City of Portland, Maine - Building or Use Permit Application
 389 Congress Street, 04101 Tel: (207) 874-8703, Fax: (207) 874-8716

Permit No: 01-092700	Issue Date: 10/01/01	CBL: 056 B011001
Location of Construction: 9 Lewis St		Owner Name: Poirier, John Michael
Business Name: n/a		Contractor Name: Poirier, John Michael
Lessee/Buyer's Name: n/a		Phone: 7254200
Past Use: Multi-Family / 7 Unit		Proposed Use: Same: Replace four Porches and Stairs Per Plans. Call John at 842-6319 when ready
Proposed Project Description: Replace four Porches and Stairs Per Plans		Permit Fee: \$42.00
		Cost of Work: \$3,000.00
		CEO District: 3
		FIRE DEPT: <input checked="" type="checkbox"/> Approved <input type="checkbox"/> Denied
		INSPECTION: Use Group: R-3 Type 5B BOCA/IBC/1999
		Signature: <i>[Signature]</i>
		PEDESTRIAN ACTIVITIES DISTRICT (P.A.D.):
		Action: <input type="checkbox"/> Approved <input type="checkbox"/> Approved w/Conditions <input type="checkbox"/> Denied
		Signature: <i>[Signature]</i> Date: <i>[Date]</i>

BUILDING PERMIT REPORT

HISTORIC PRESERVATION REVIEW

BACK PORCH
9-11 LEWIS ST
PORTLAND ME.

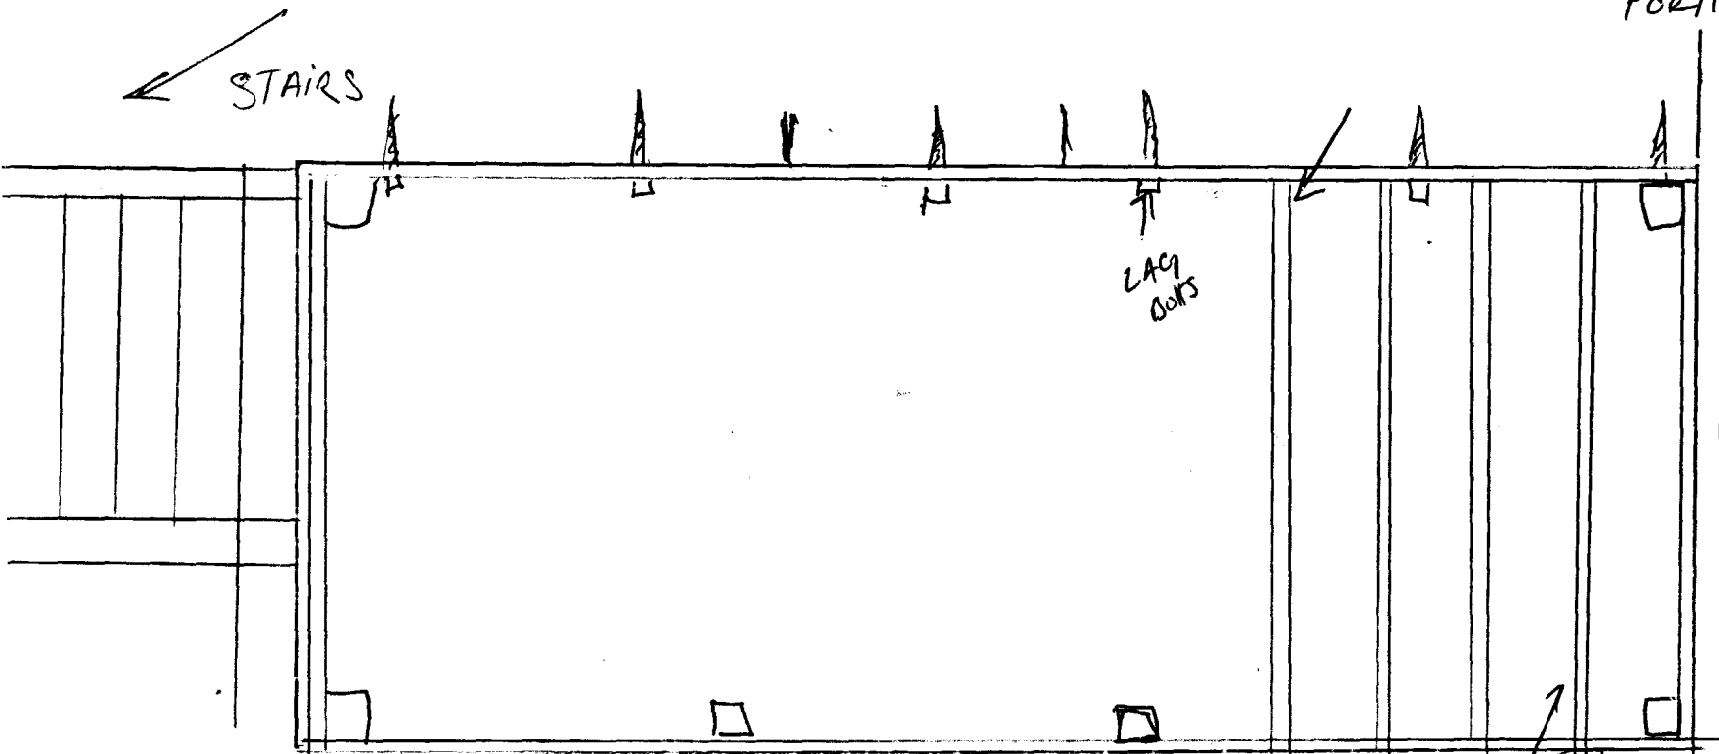
1. THE CONSTRUCTION + FINISHING OF THE PROPOSED DECK + STAIRS AT #1, #9A, + #11B ARE TO MATCH THAT OF THE NEW DECK + STAIRS AT #7 + #9, INCLUDING THE DESIGN OF THE RAILINGS, BALUSTERS, POSTS, LATTICE SKIRTING, AND TRIM.
2. THE REPLACED DECKING, HANDRAILS, AND COLUMNS ON FRONT PORCH #9 ARE TO MATCH THOSE ON #11.
3. THE REPLACED DECKING, HANDRAILS, BALUSTERS, COLUMNS, + BASES ON FRONT PORCH #11 ARE TO MATCH THE ORIGINALS IN DESIGN, MATERIAL, + DIMENSIONS, EXCEPT WHERE REQUIRED TO MEET CODE REQUIREMENTS.
